BOARD OF ZONING APPEALS DIVISION II

Case Number: 2025-DV1-052 (Amended)
Property Address: 4105 West 93rd Street (approximate address)
Location: Pike Township, Council District #1
Petitioner: V 465 LLC, by John B. Gregg
Current Zoning: I-2 / MU-1
Request: Variance of Development Standards of the Consolidated Zoning and Subdivision Ordinance to provide for the development of a warehouse exceeding one double-loaded row of parking in front of a building (not permitted) and the removal of heritage trees without prior authorization (not permitted).
Current Land Use: Undeveloped
Staff Recommendations: Staff recommends **approval** of the requested variances.
Staff Reviewer: Michael Weigel, Senior Planner

2025DV1052 ; Landscape Plan

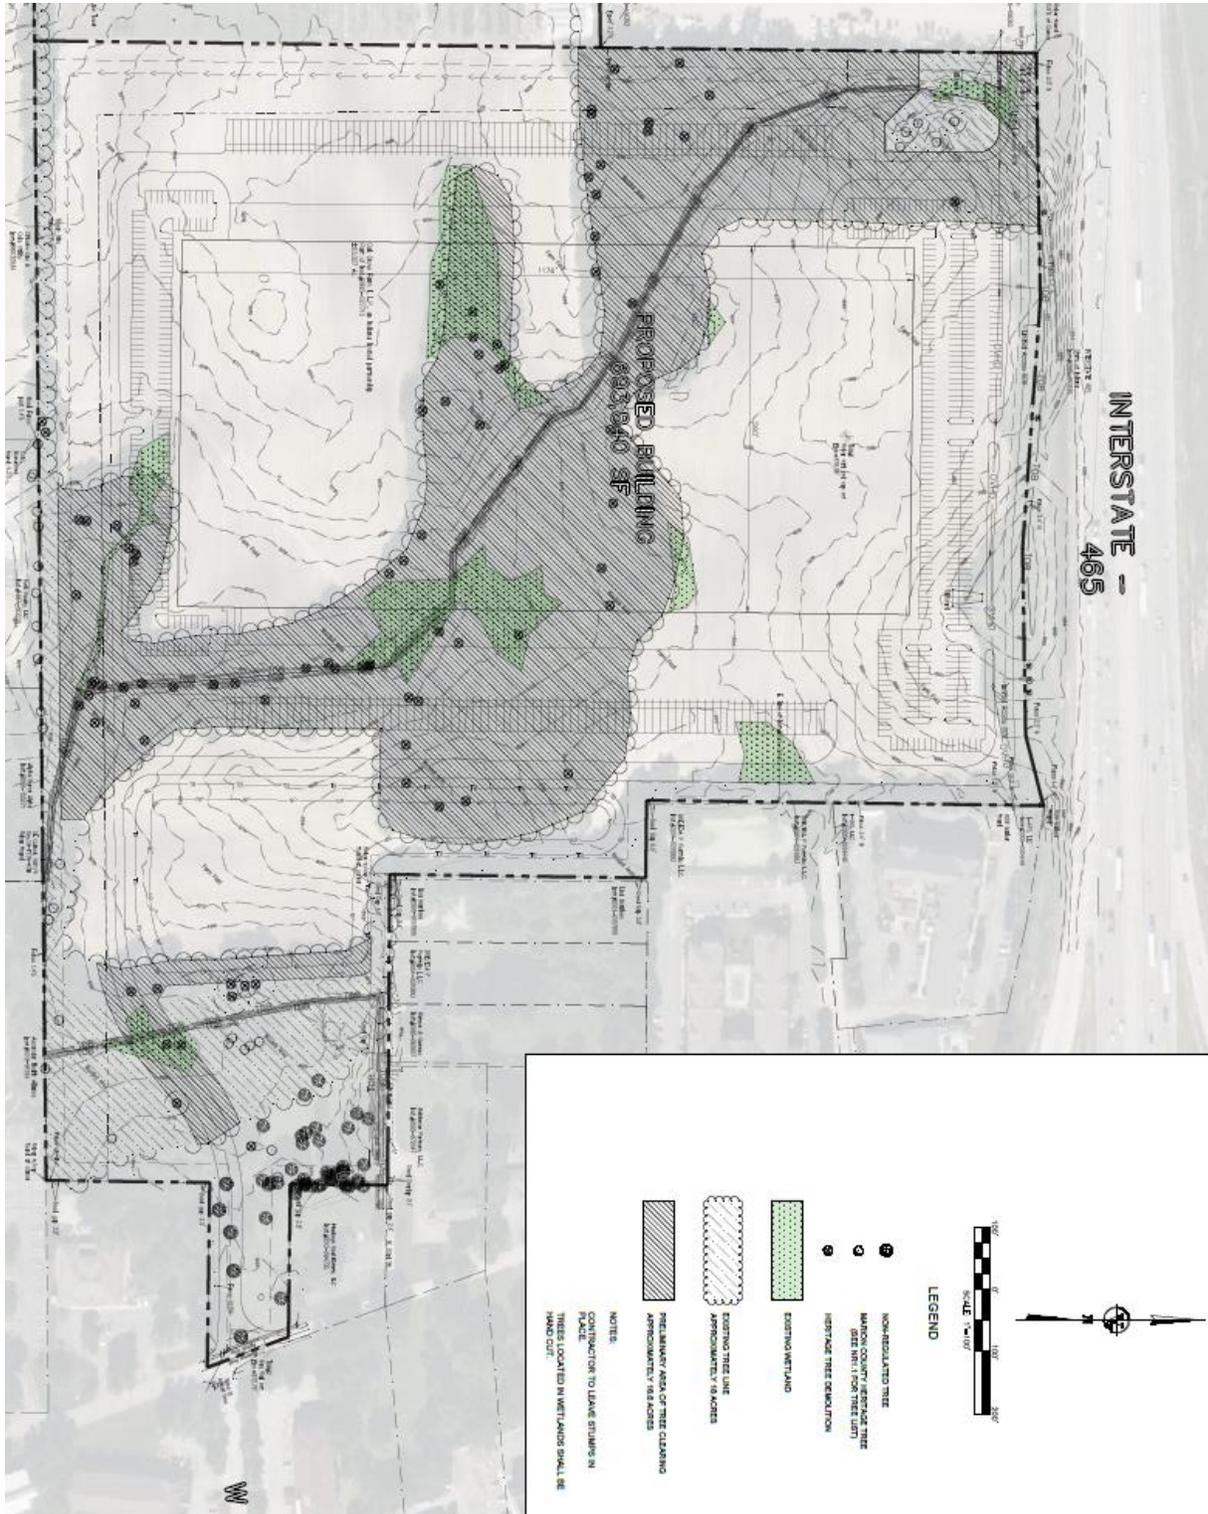
- A full landscape plan showing proposed plantings was provided by the applicant in February, per staff request. Those plans indicate that no additional variances related to landscaping would be required: required perimeter, interior parking areas, and transitional yard plantings would be provided, and the Green Factor score would be a compliant 0.3178. Approval of this petition would not allow for deviation from these standards or from any rules related to the planting of replacement trees for any heritage trees removed at the site.
